Dewberry Response to USGS Review of the Virginia Fairfax County Lidar Project

Produced for U.S. Geological Survey

USGS Contract: G16PC00020

Task Order: 140G0218F0214

Figure 2 – Tiles e1599n1900 and e1600n1900. The image above is an overview of the DEM where USGS made a call that a waterbody was not hydroflattened to a single elevation.

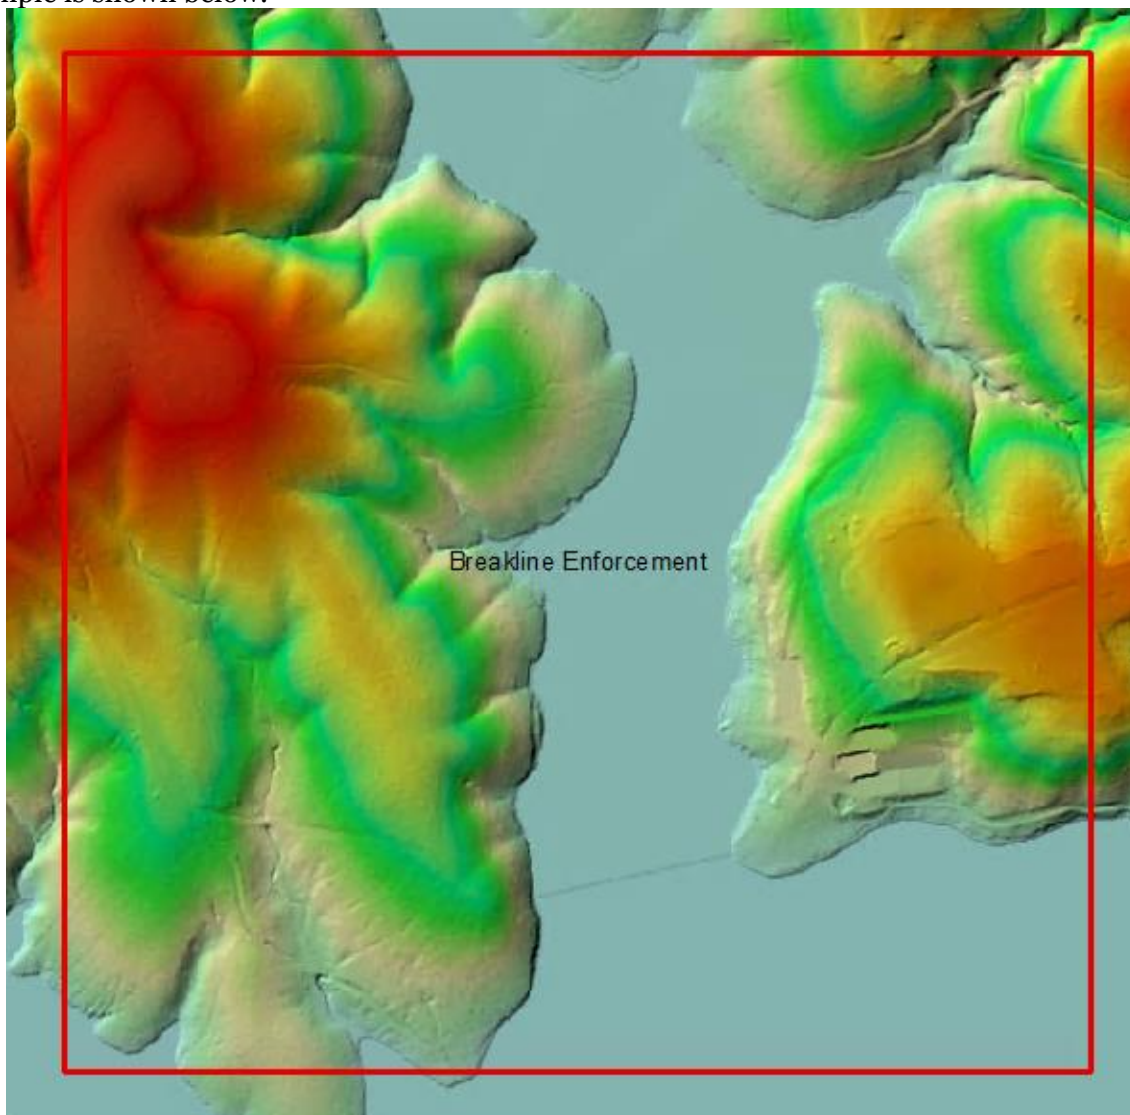
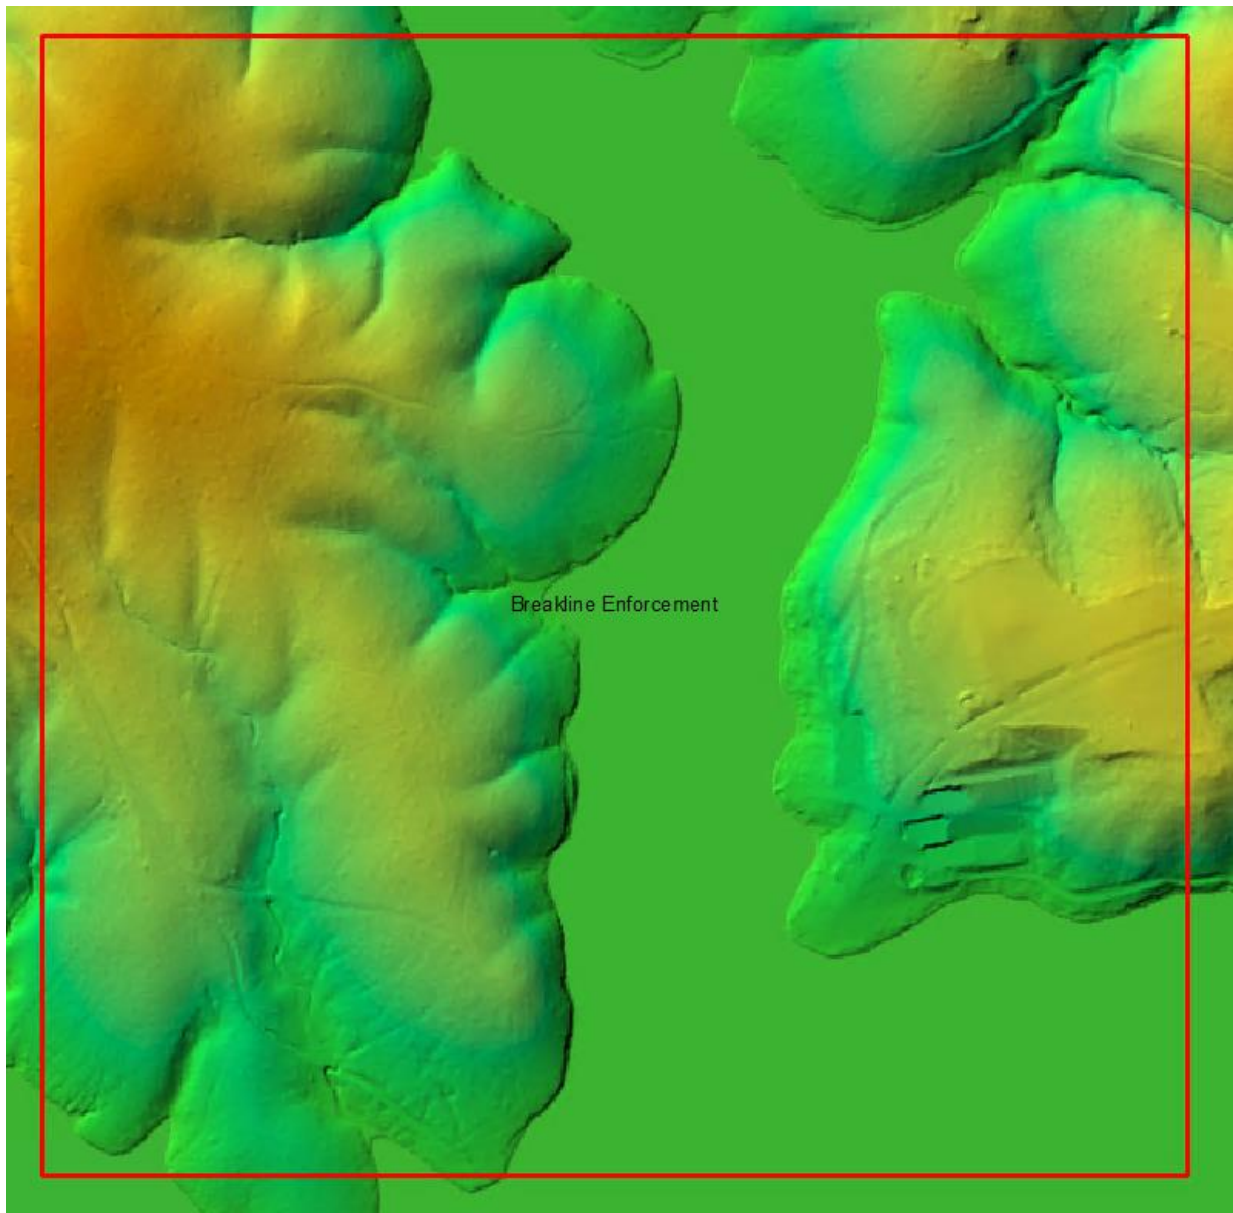
USGS made three (3) calls where a waterbody was not hydroflattened to a single elevation value. Dewberry has addressed these calls and the ~~LAS~~ breaklines and DEMs were corrected. An example is shown below.

Figure 3 – Tiles e1599n1900 and e1600n1900. The image above is an overview of the corrected DEM.

Figure 4 – Tile e1591n1929. The image on the left is an overview of the DEM where USGS made a call that there was a bridge artifact visible on the DEM after the bridge was removed. The image on the right is an overview of the corrected DEM.

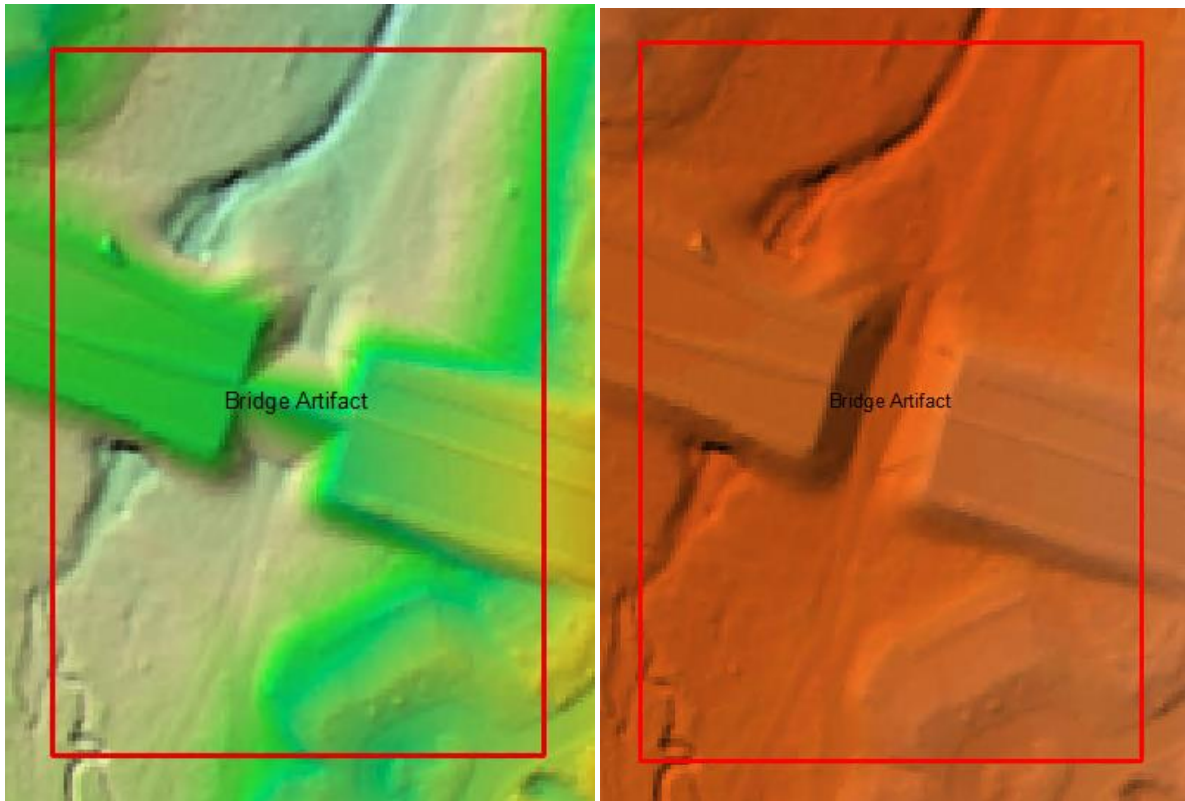
USGS made ten (10) calls where there was a bridge artifact visible on the DEM after the bridge was removed. Dewberry has addressed these calls and the bridge saddle LAS breaklines and DEM_s were corrected. An example is shown below.

Figure 5 – Tile e1591n1929. The image on the left is an overview of the DEM where USGS made a call that a bridge deck was not removed from the DEM surface. The image on the right is an overview of the corrected DEM.

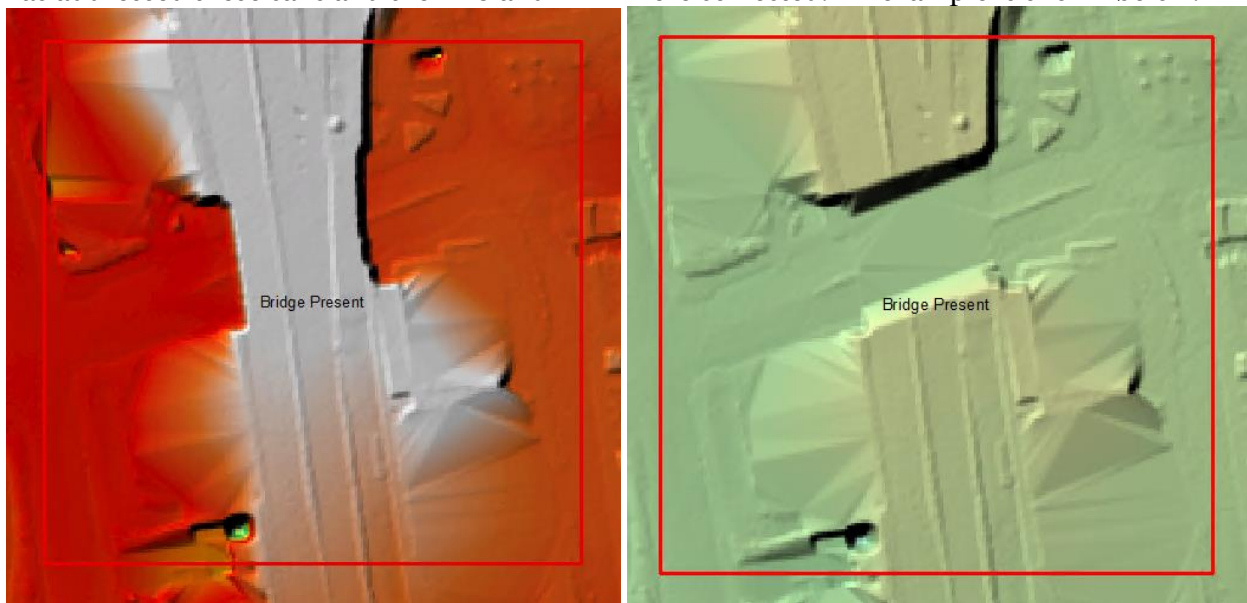
USGS made eight (8) calls where a bridge deck was not removed from the DEM surface. Dewberry has addressed these calls and the LAS and DEM were corrected. An example is shown below.

Figure 6 - Tiles e1613n1894, e1613n1895, e1614n1894, e1614n1895. The image on the left is an overview of the DEM where USGS made a call stating that a stream wider than 30m did not have breaklines and was not hydroflattened. The image on the right is an overview of the corrected DEM.

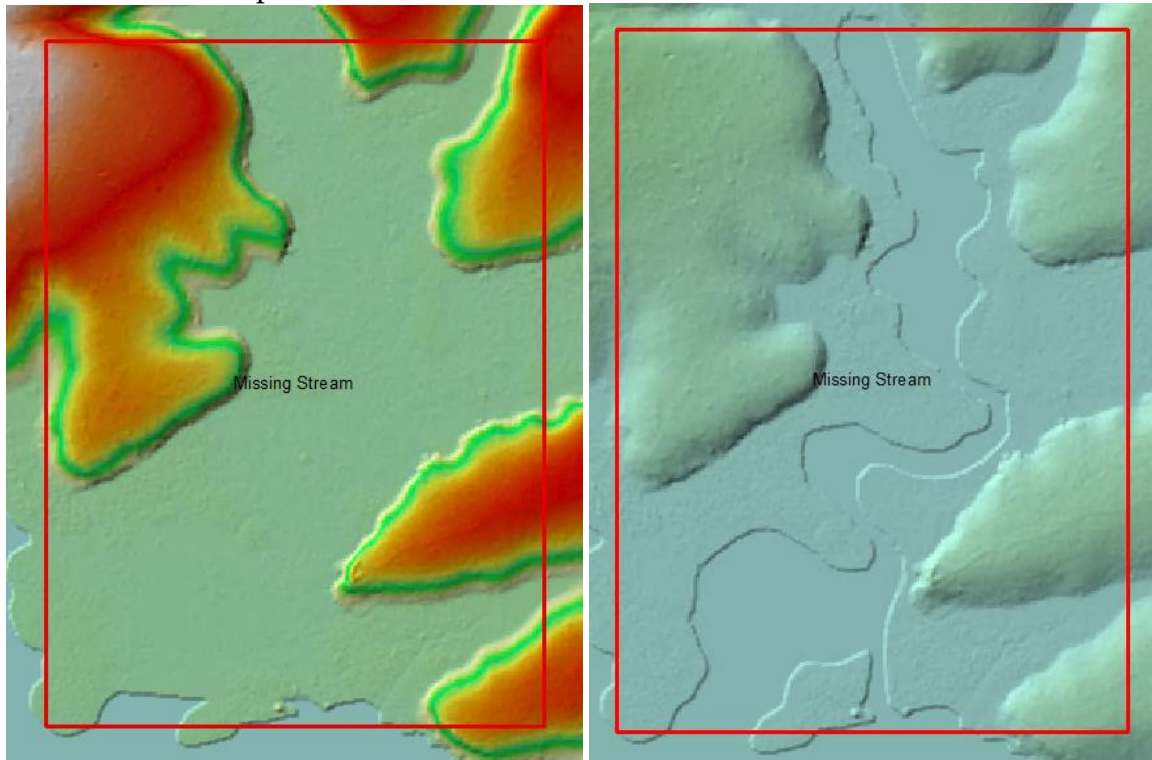
USGS made two (2) calls where a stream wider than 30m did not have breaklines and was not hydroflattened. Dewberry has addressed these calls and the LAS, breaklines, and DEMs were corrected. An example is shown below.

Figure 7 – Tiles e1597n1936 and e1595n1936. The image above is an overview of the DEM where USGS made a call stating that only part of an island was marked with breaklines.

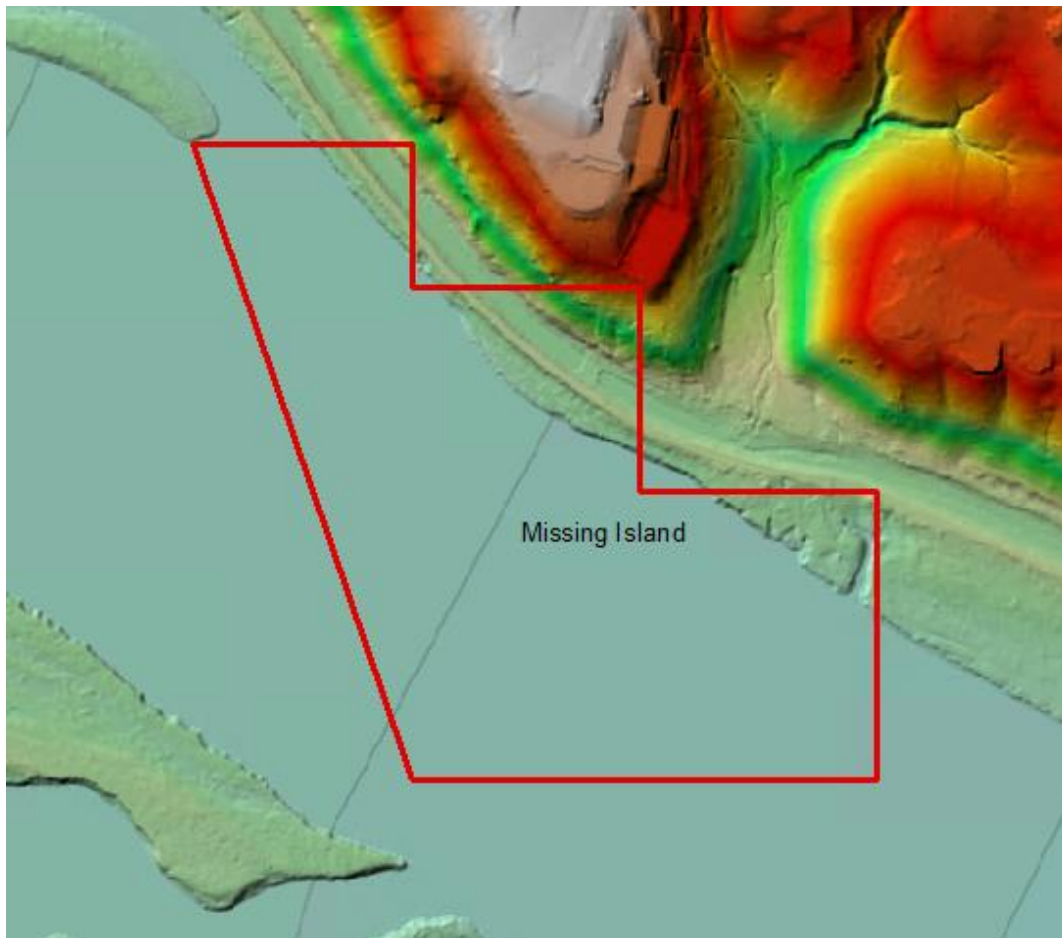
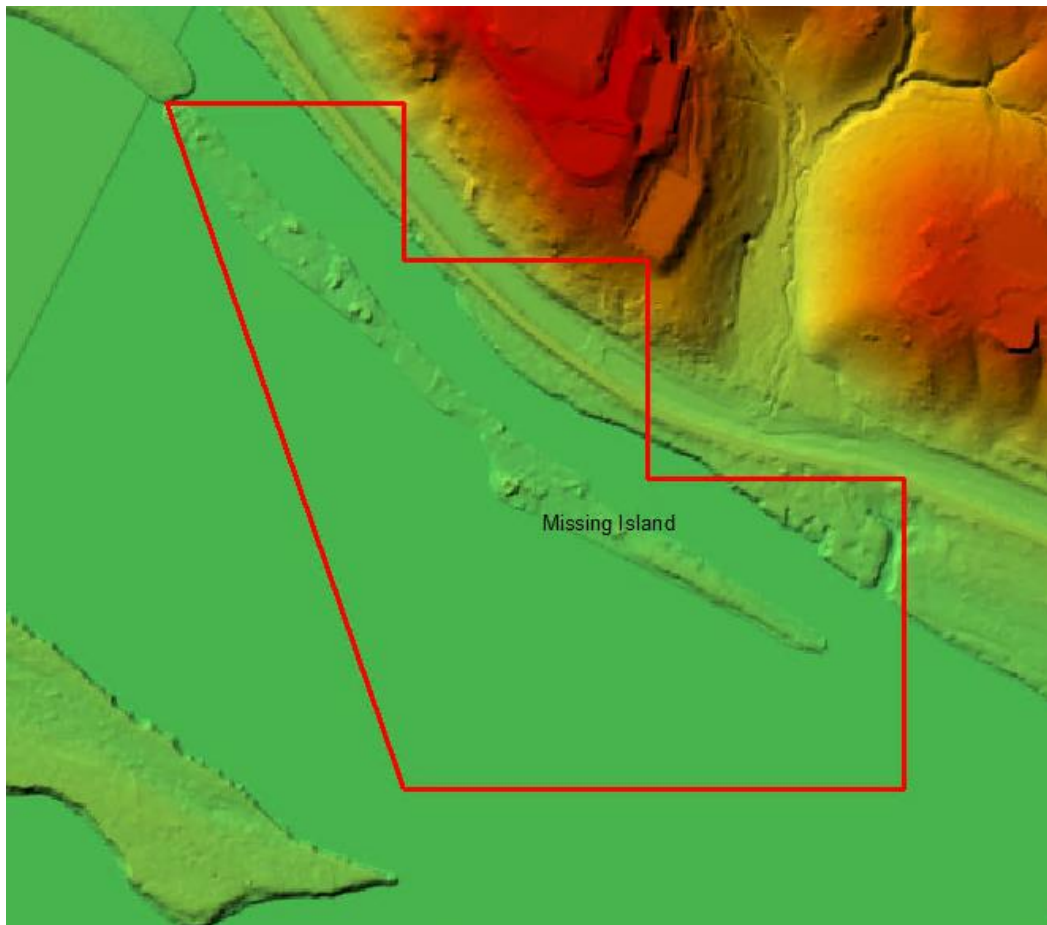
USGS made one (1) call where only part of an island was marked with breaklines. Dewberry has addressed this call and the LAS, breaklines, and DEMs were corrected.

Figure 8 – Tiles e1597n1936 and e1595n1936. The image above is an overview of the corrected DEM.

Figure 11 – Tile e1615n1925. The image above shows an overview of the DEM where USGS made a call stating a stream was not properly hydroflattened in a downstream manner.

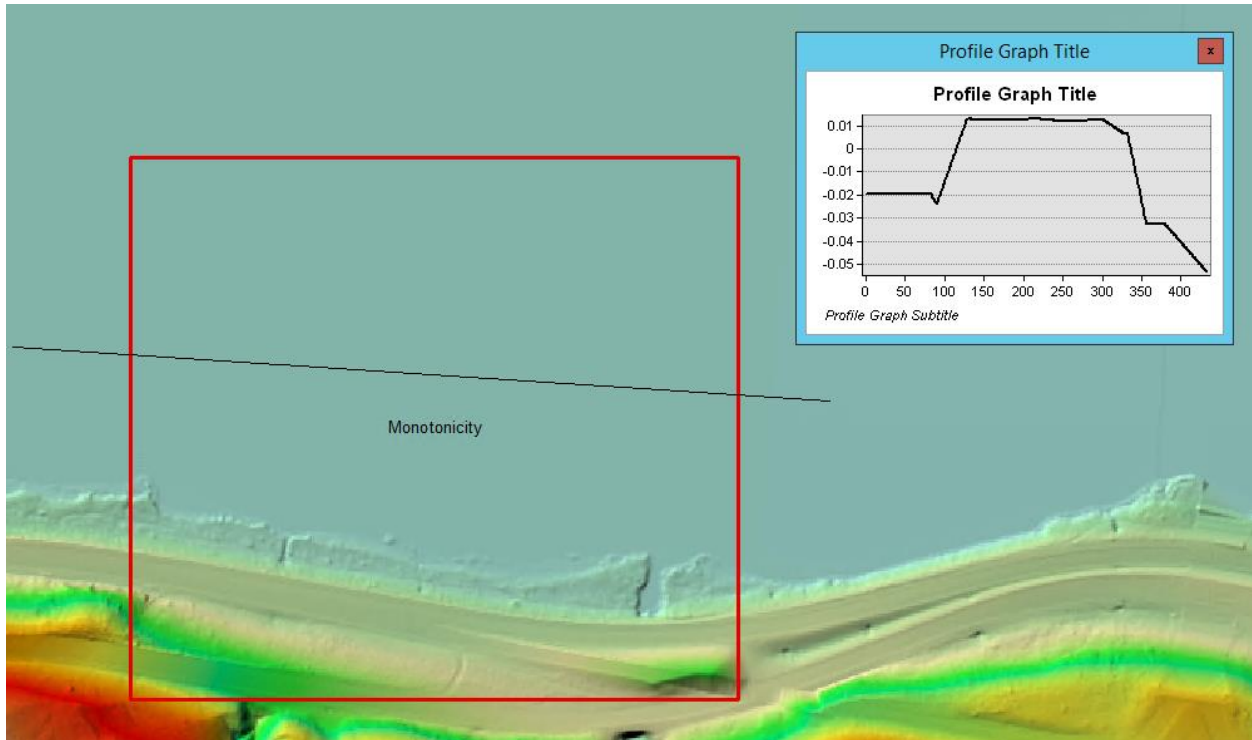
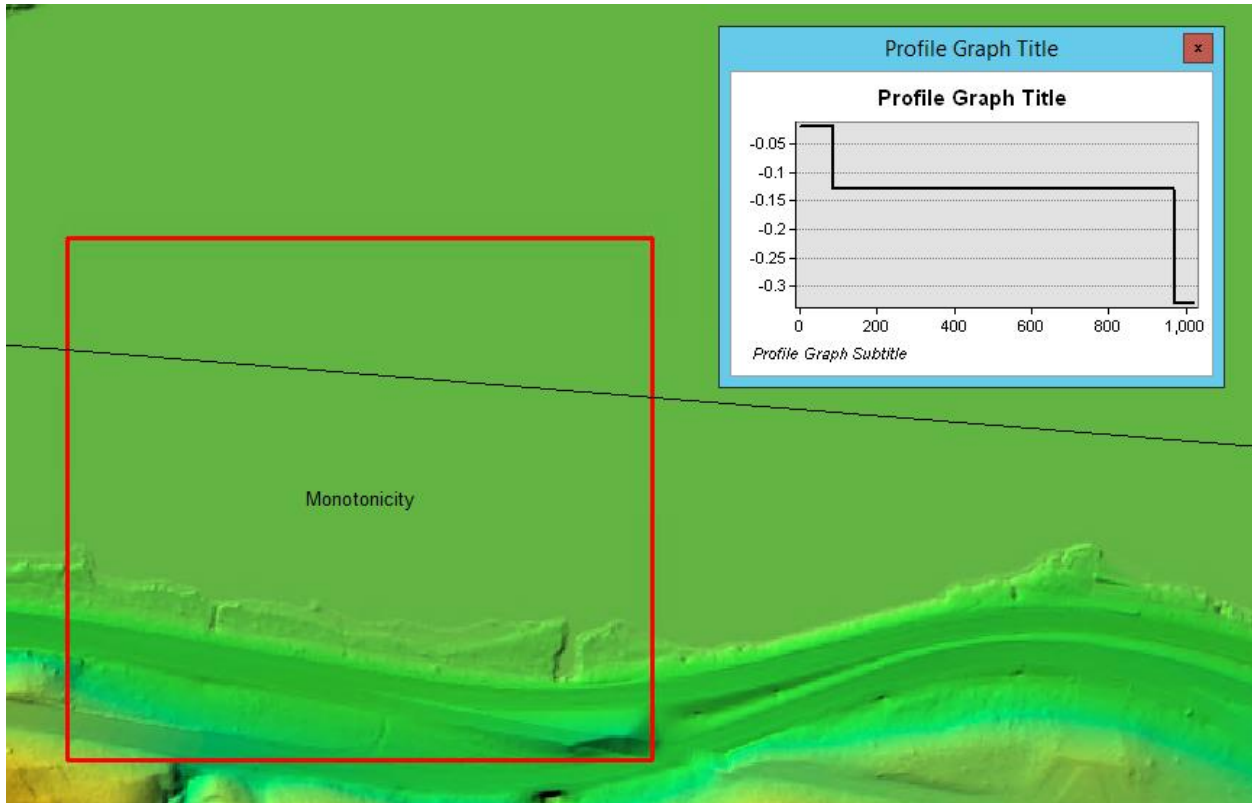
USGS made two (2) calls where a stream was not properly hydroflattened in a downstream manner. Dewberry has addressed these calls and the LAS, breaklines, and DEMs were corrected. An example is shown below.

Figure 12 – Tile e1615n1925. The image above shows an overview of the corrected DEM.

Figure 13 - Tile e1584n1918. The image on the left shows an overview of the DEM where USGS made a call stating that there were building points mistakenly misclassified as ground points. The image on the right is an overview of the corrected DEM.

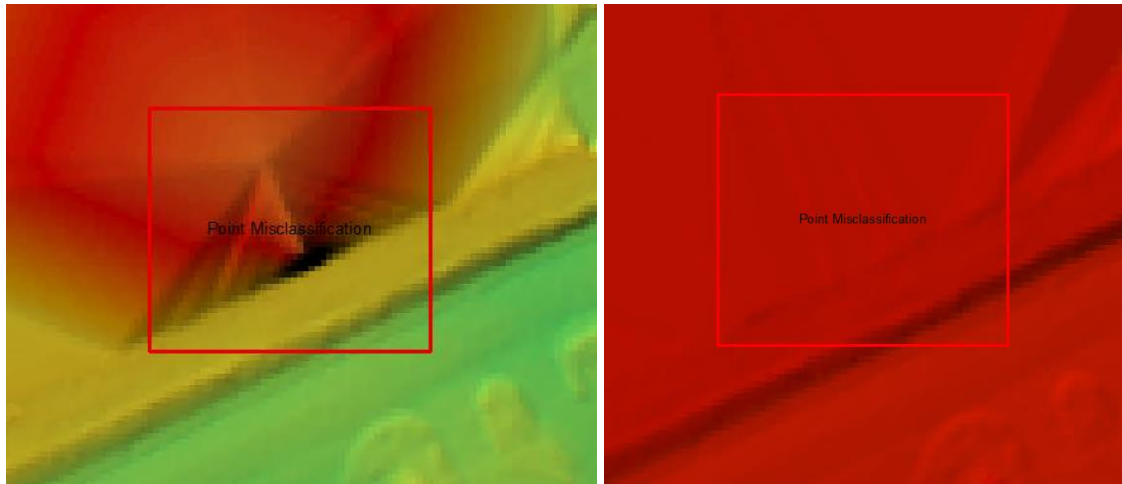
USGS made three (3) calls where there were building points mistakenly classified as ground points. Dewberry has addressed these calls and the LAS and DEMs were corrected. An example is shown below.
